2.0 SITE CHARACTERISTICS

Section 2.1 of the South Texas Project (STP) Units 3 and 4 combined license (COL) FSAR incorporates by reference Section 2.1 of the certified Advanced Boiling-Water Reactor (ABWR) design control document (DCD) Revision 4, referenced in Title 10 of the *Code of Federal Regulations* (10 CFR) Part 52, "Licenses, Certifications, and Approvals for Nuclear Power Plants," Appendix A, "Design Certification Rule for the U.S. Advanced Boiling Water Reactor," with no departures. In addition, in FSAR Section 2.1S.1, the applicant provides site-specific information on site location and a description that addresses COL License Information Item 2.3 as summarized below:

Figure 2.3S.2-1. Comparison of 1997, 1999, and 2000 Wind Direction Frequency Distributions

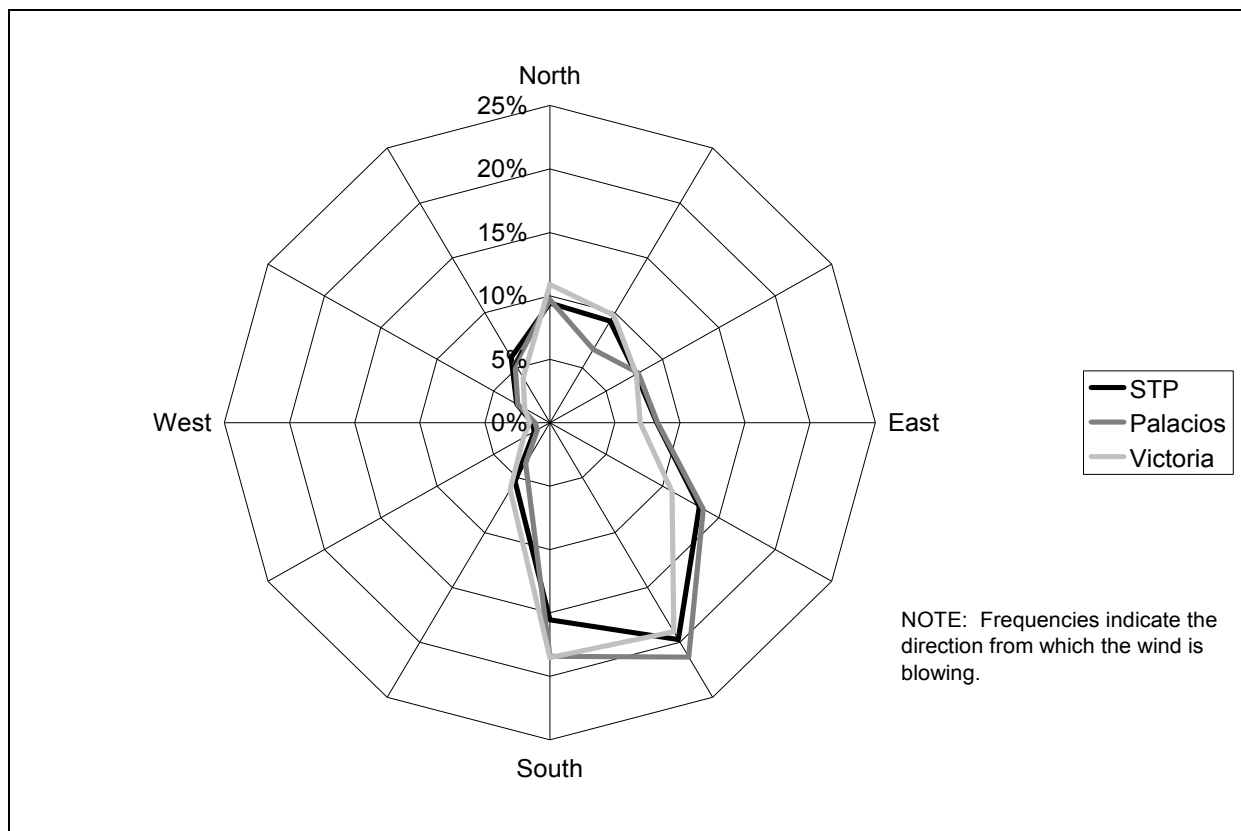
In order to confirm this hypothesis, the staff generated a comparison of annual wind direction frequencies among the STP, Palacios, and Victoria hourly data for the years 1997, 1999, and 2000. This comparison, shown in SER Figure 2.3S.2-1, indicates a similar distribution among all three sites. The staff also compared annual average wind speeds among all three sites for the same three-year time period. The staff found that the STP 10-m (33-ft) level average wind speed of 4.1 m/s (13.5 ft/s) is consistent with the 6.1-m (20.0-ft) level average wind speed of 4.1 m/s (13.5 ft/s) at Victoria but somewhat lower than the 5.0 m/s (16.4 ft/s) average wind speed recorded at Palacios. The staff issued RAI 02.03.02-4a requesting the applicant to justify not including meteorological data from Palacios in the review of average wind direction and wind speed conditions discussed in Revision 0 of FSAR Tier 2, Section 2.3S.2.2.1.

Figure 2.3S.3-3. STP Stability Class Frequency Distributions

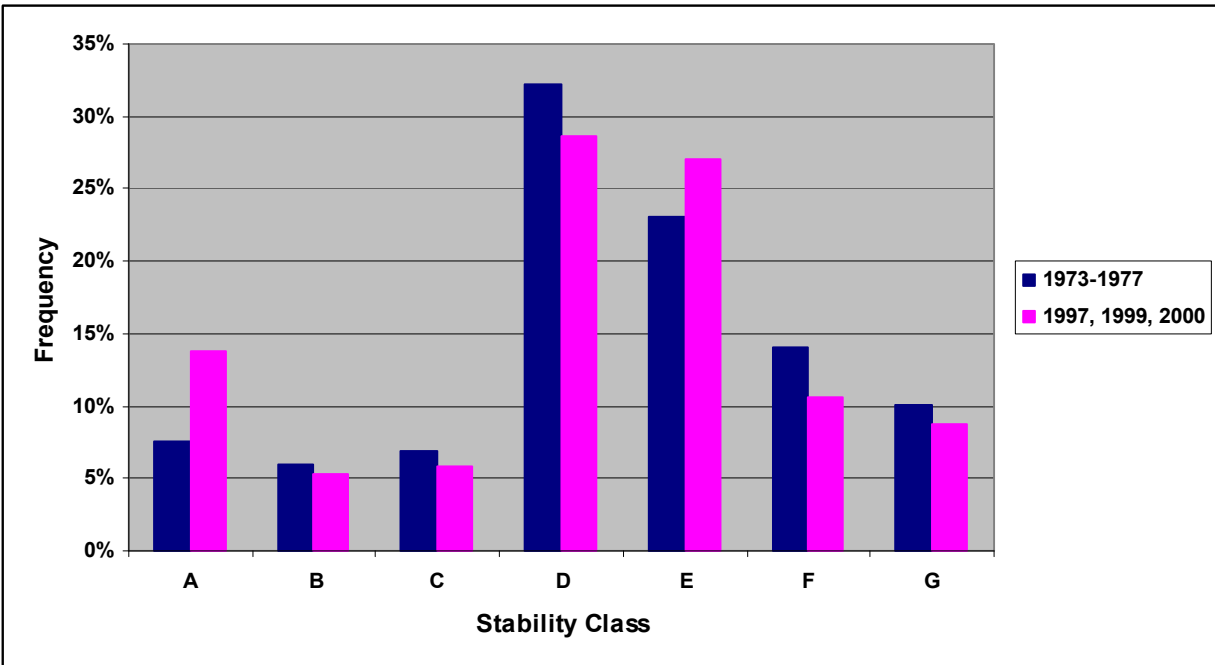
The stability class frequency distribution for both data sets in SER Figure 2.3S.3-3 also show reasonable agreement. Nonetheless, the staff issued RAI 02.03.03-3 asking the applicant to explain the 6 percent frequency increase of onsite Stability Class A (extremely unstable) conditions from the original data set to the current data set (see SER Figure 2.3S.3-3).
